To be held on Monday, September 29, 2014 at **2:00 p.m.** Committee Members are asked to meet in the **Council Chambers** at 395 Mulock Drive, Newmarket, Ontario.

1. Application for Site Plan Approval p. 1
212 Davis Drive - Ward 5
(South Side of Davis Drive, East of Parkside Drive)
Our File No.:D11-NP1404 & D14-NP1404
Green & Rose Developments Inc.

Application for Site Plan Approval to permit a new 15-storey rental apartment building containing 225 units together with an accessory parking structure on the subject lands.

2. Request for Exemption from Telecommunications Tower Protocol
912 Bosworth Court - Ward 6
(South of Mulock Drive, East of Yonge Street)
The Regional Municipality of York

Proposed location of new
5m high radio antenna pole

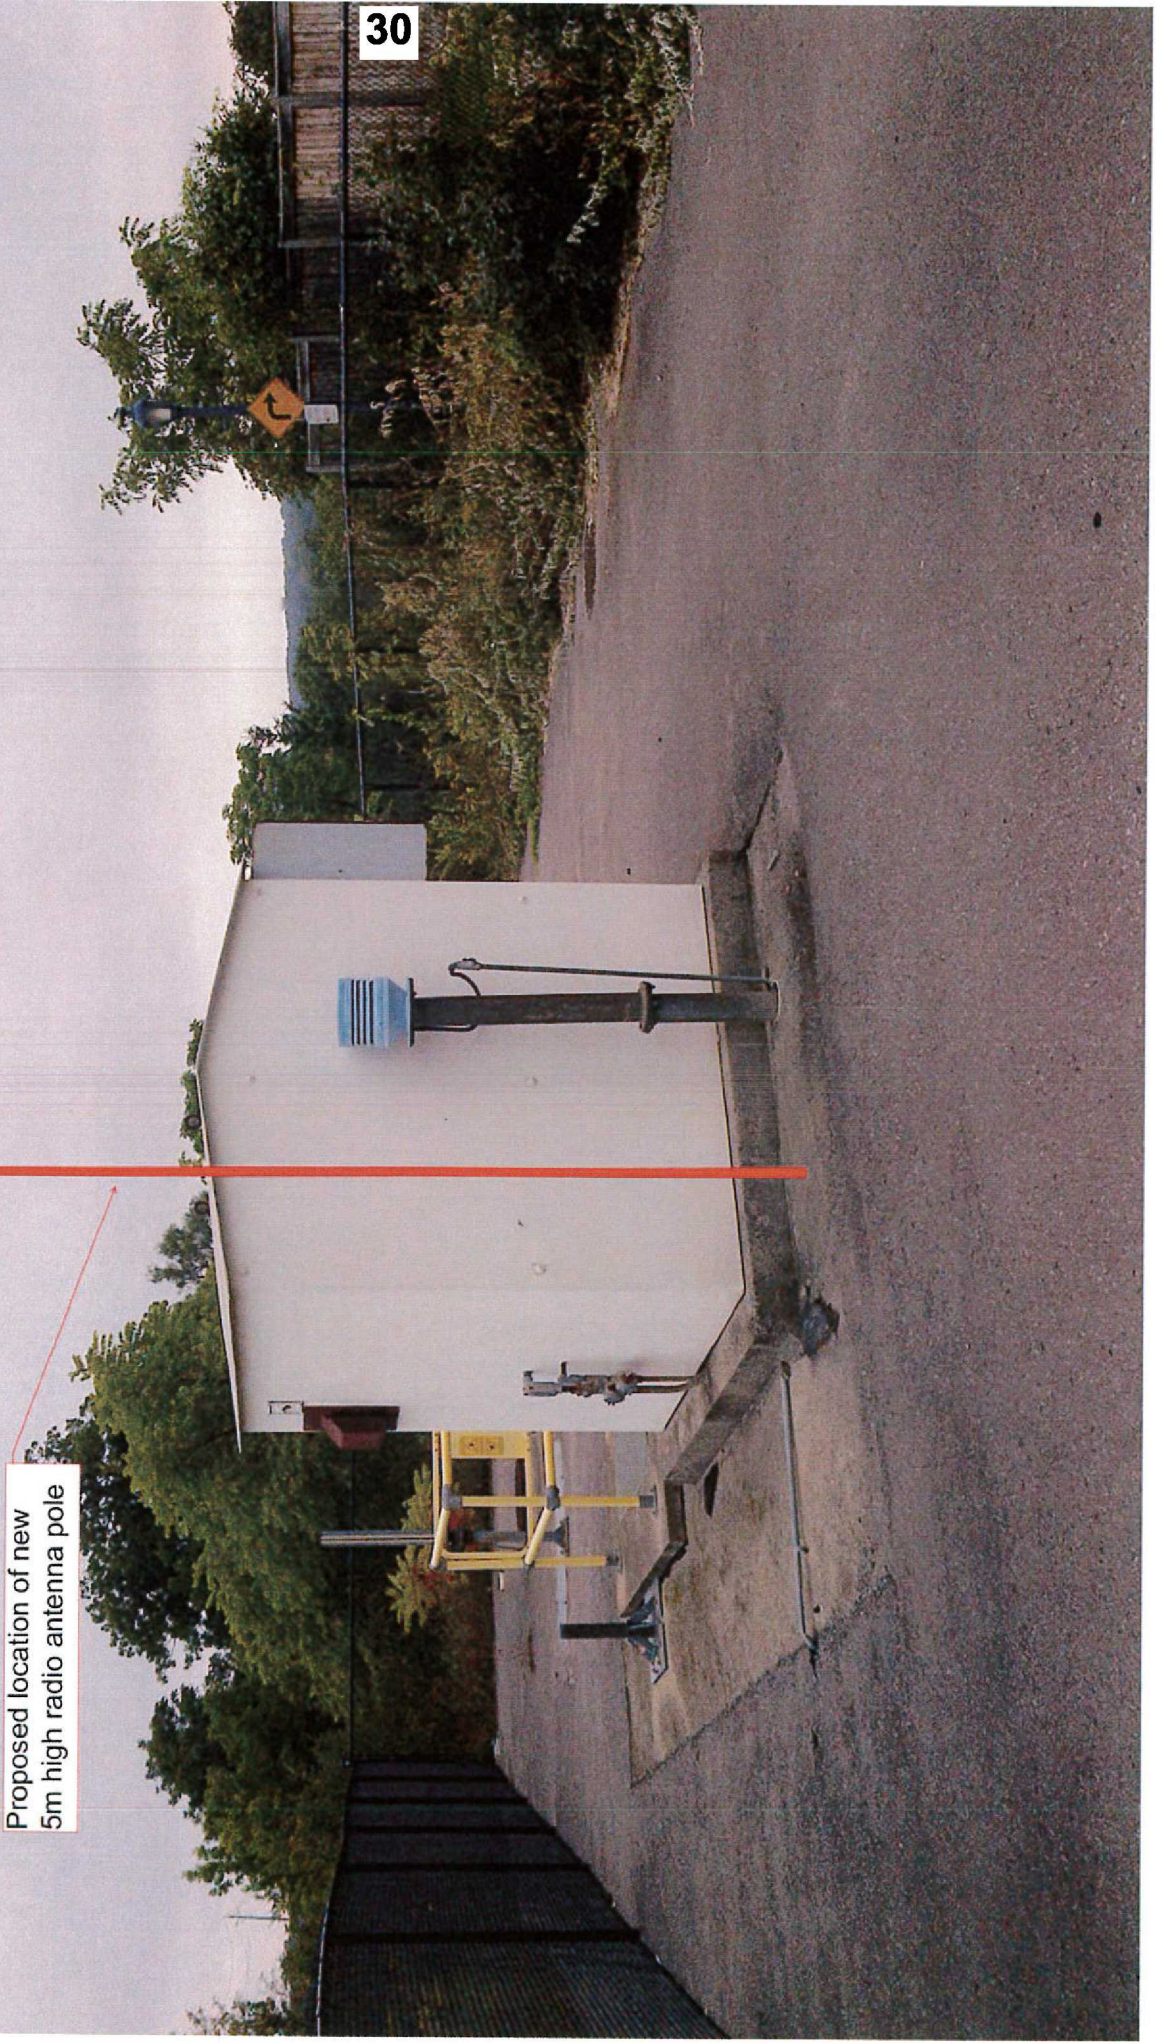
- Applicant is requesting exemption from Town's telecommunication tower protocol to permit installation of a 5 metre high radio antenna pole that will provide a communication link to Region's Supervisory Control and Data Acquisition (SCADA) system
- Use is regulated by Industry Canada
- Town's protocol provides an exemption from municipal approval for towers constructed on buildings that are no more than 16.6 metres in height above grade; however, no exemption is provided for free-standing towers
- Town's protocol and Industry Canada grant exemption from public consultation
- If Committee should chose to grant an exemption, staff would recommend the applicant be directed to provide an information letter to area residents advising of proposed work
